HISTORIC AND DESIGN REVIEW COMMISSION

HDRC CASE NO: 2018-054
ADDRESS: 1021 N PALMETTO
LEGAL DESCRIPTION: NCB 1369 BLK 6 LOT N 46 FT OF 8 & 9 ARB A-1
ZONING: R-4 H
CITY COUNCIL DIST.: 2
DISTRICT: Dignowity Hill Historic District
APPLICANT: Ricardo McCullough
OWNER: Imagine Holdings
TYPE OF WORK: Construction of a 2-story residential structure
APPLICATION RECEIVED: January 24, 2018
60-DAY REVIEW: March 25, 2018

The applicant is requesting final approval to construct a 2-story single family home on the vacant lot at 1021 N Palmetto.

NEW SPEC HOME

SITE PLAN

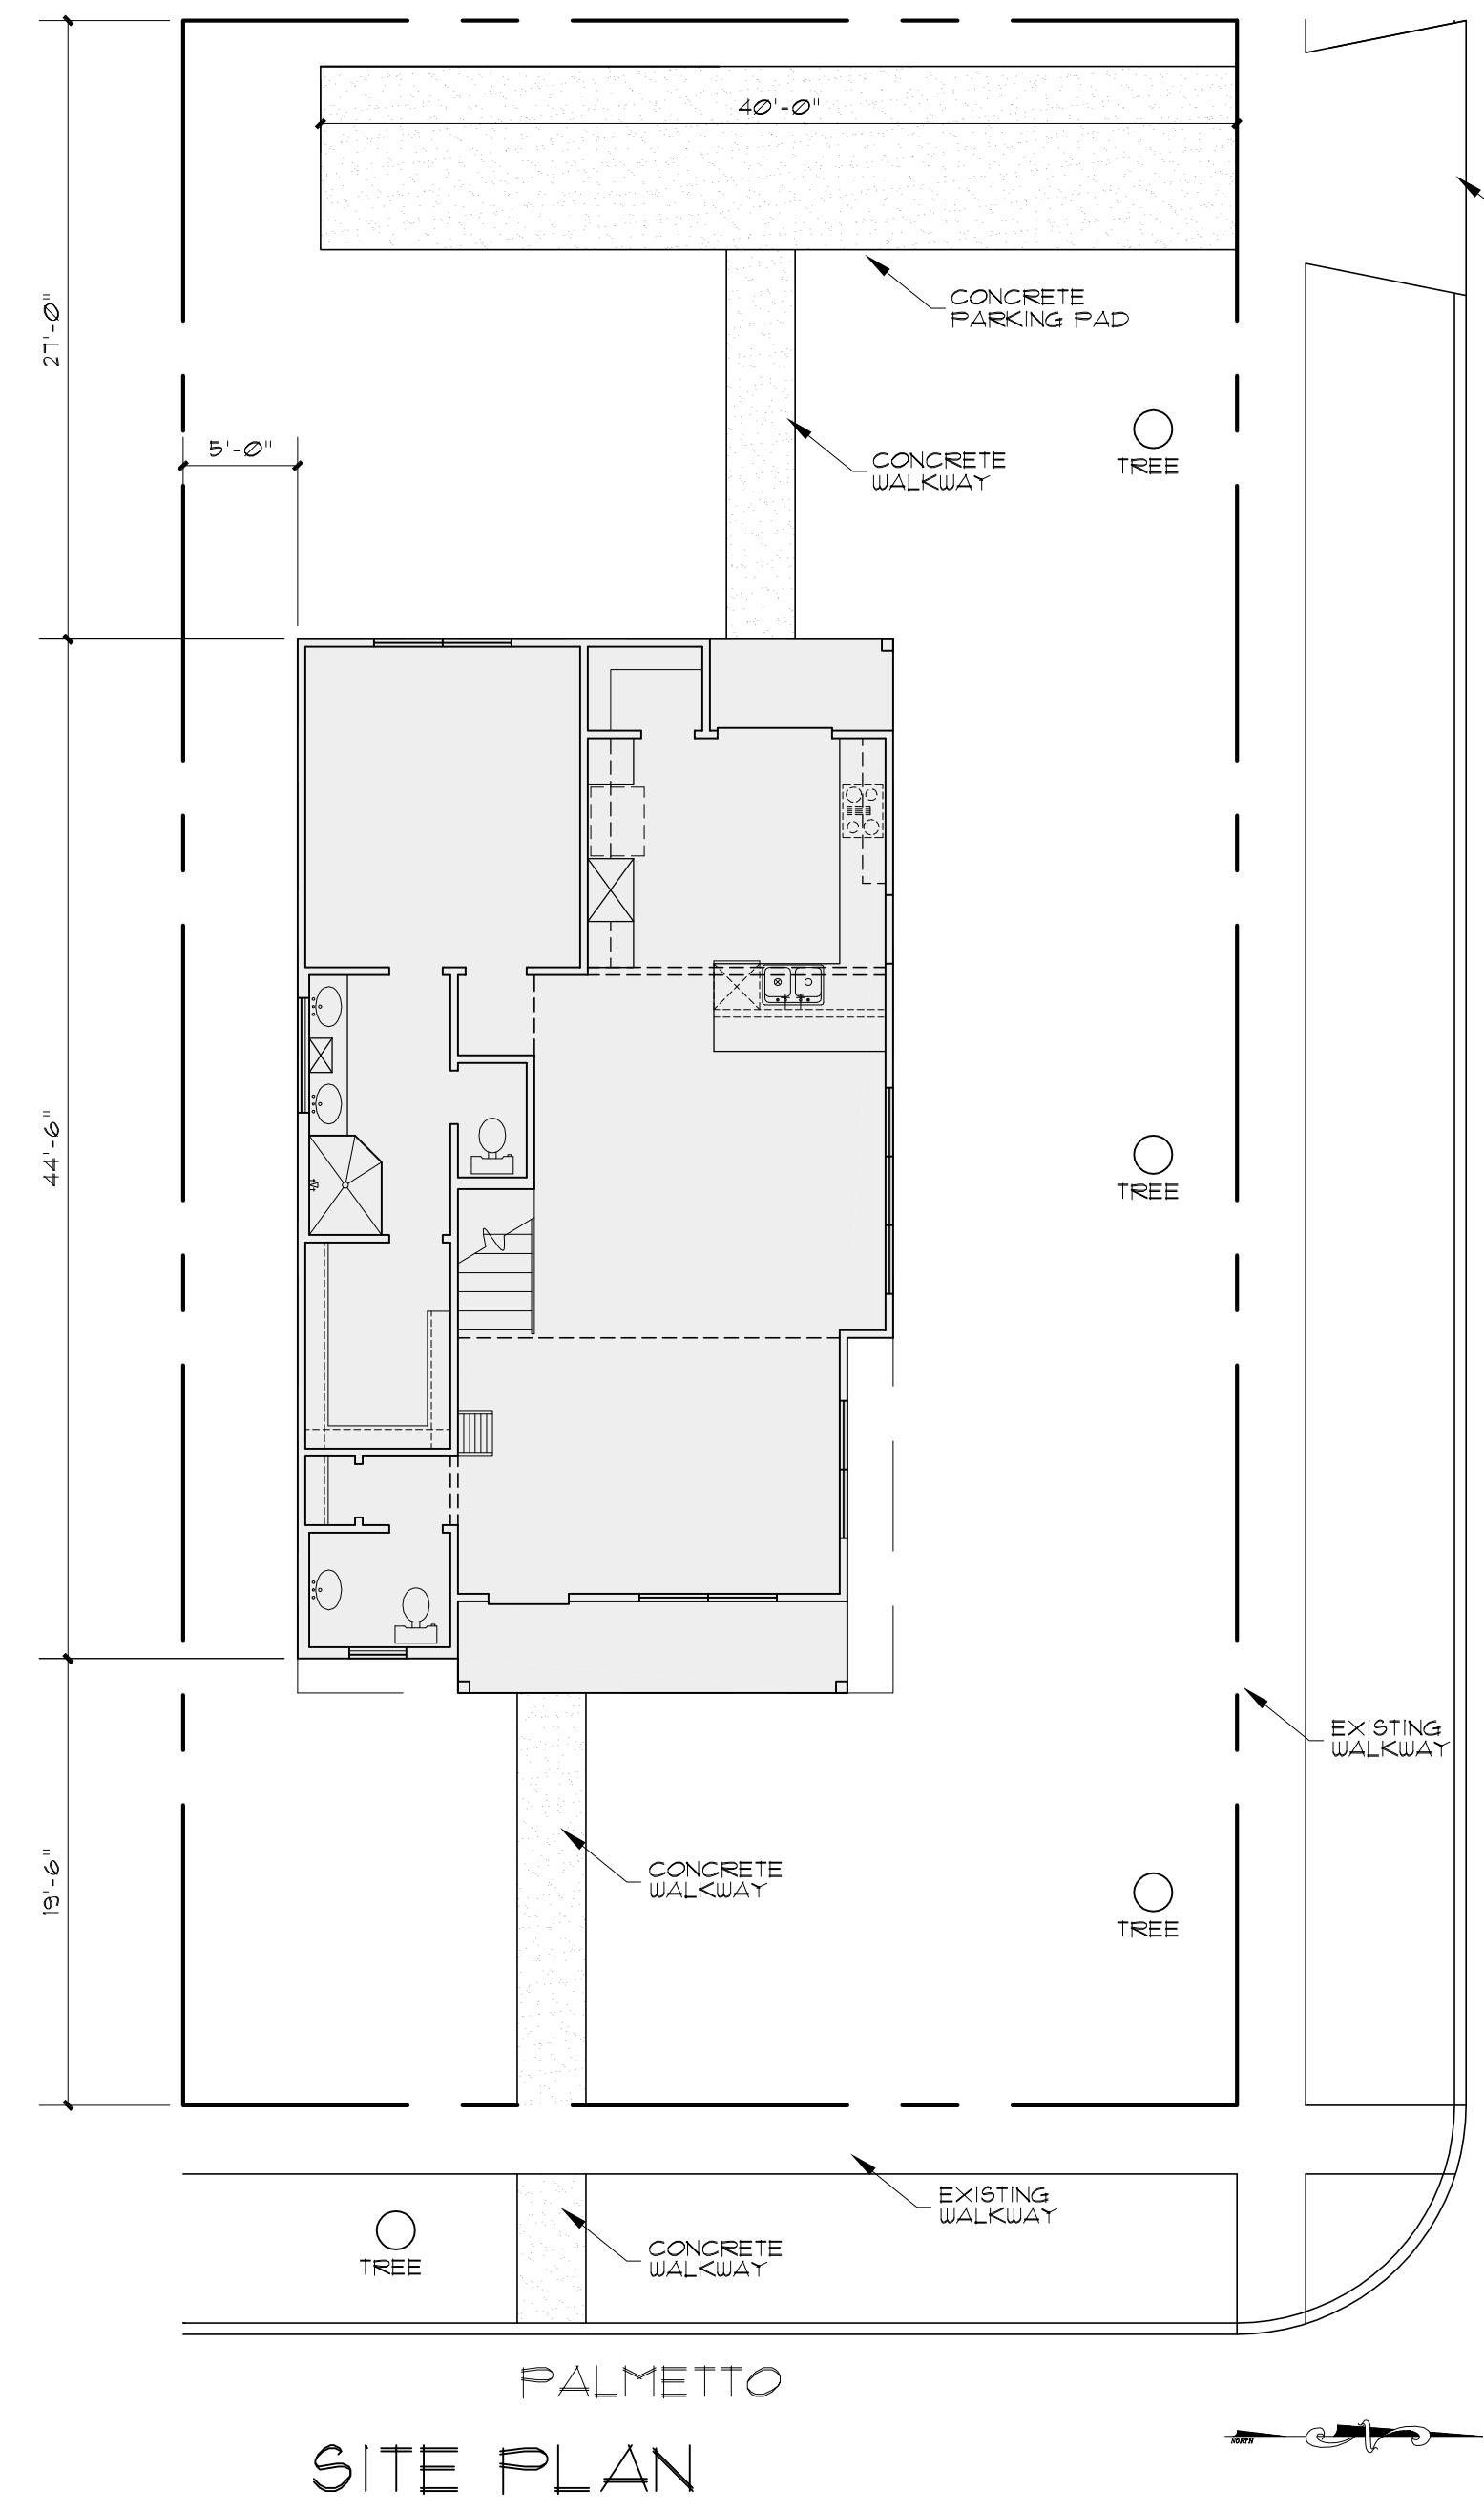
6. **That the applicant submits a comprehensive hardscaping and landscaping plan for final approval that indicates all mechanical equipment and screening methods, if applicable;** this stipulation has been partially met in the current submittal.

- u. LANDSCAPING – The applicant has proposed to retain several existing trees on the site per the indicated site plan. The applicant is required to coordinate with the City Arborist's office to ensure the proposed new construction will not impact any significant or heritage trees. Additionally, the applicant has verbally stated their intent for installing additional appropriate small trees and shrubbery in the front yard. The applicant is required to submit a landscaping plan that indicates all of these elements to staff for review and approval prior to receiving a Certificate of Appropriateness.

Add small vertical window in powder room. Add ganged windows in bedroom. Ensure left elevation shares pattern of the rest of the facades. *SUBMIT ALL proposed landscaping.

LEFT ELEVATION

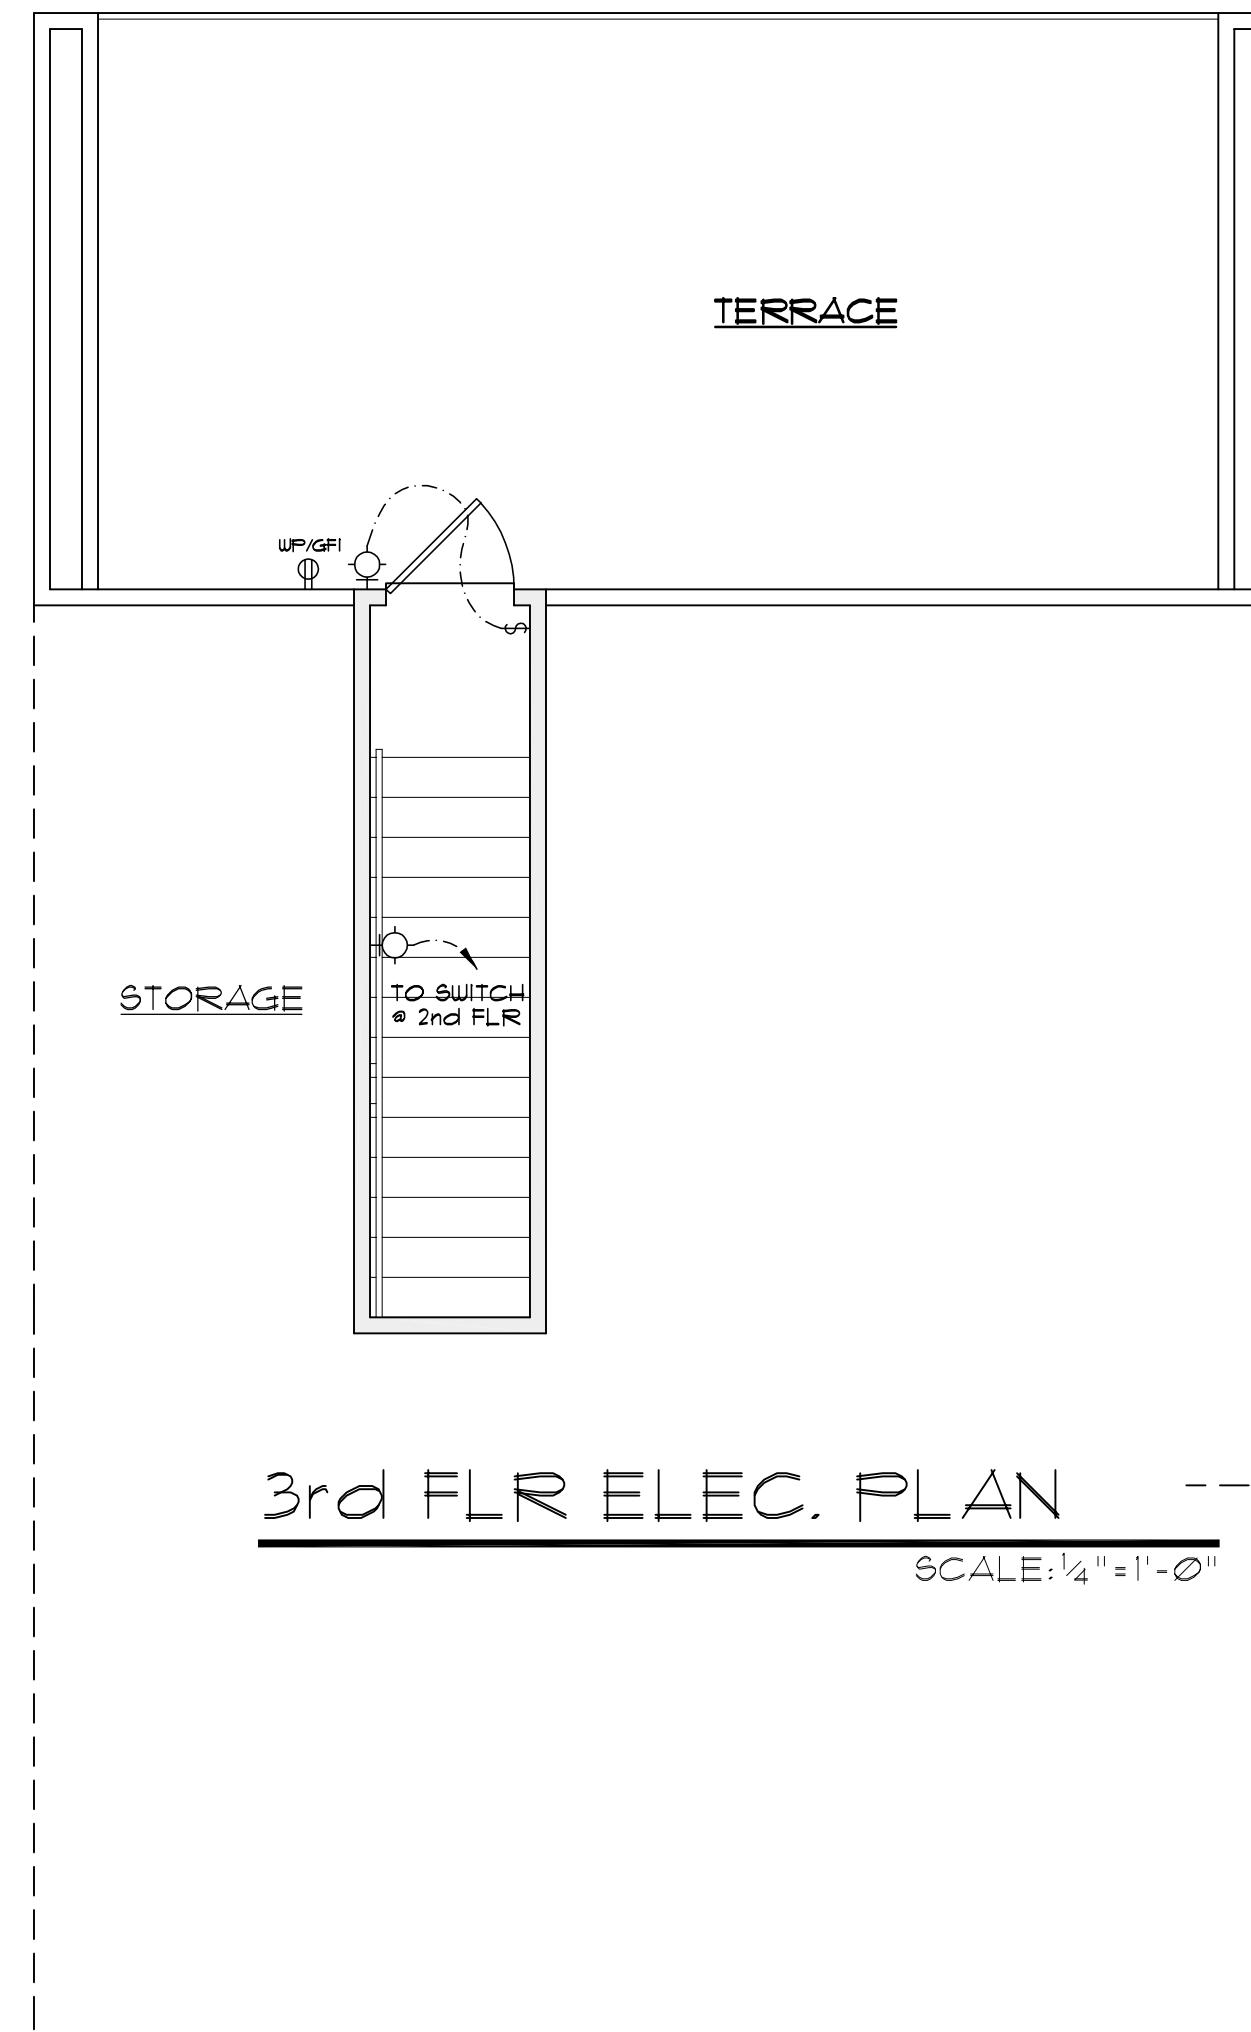
4. **That the applicant proposes windows on the left elevation that feature proportions and configurations that are more consistent with historic window patterns in the district as noted in finding j. Staff finds one over one windows to be appropriate and encourages the applicant to carry the window pattern of the three other elevations over to the left elevation for consistency;** this stipulation has partially been met in the current submittal.

- iv. That the applicant proposes windows on the left elevation that feature proportions and configurations that are more consistent with historic window patterns in the district as noted in finding j. Staff finds one over one windows to be appropriate and encourages the applicant to carry the window pattern of the three other elevations over to the left elevation for consistency. All windows on the structure should feature architecturally appropriate
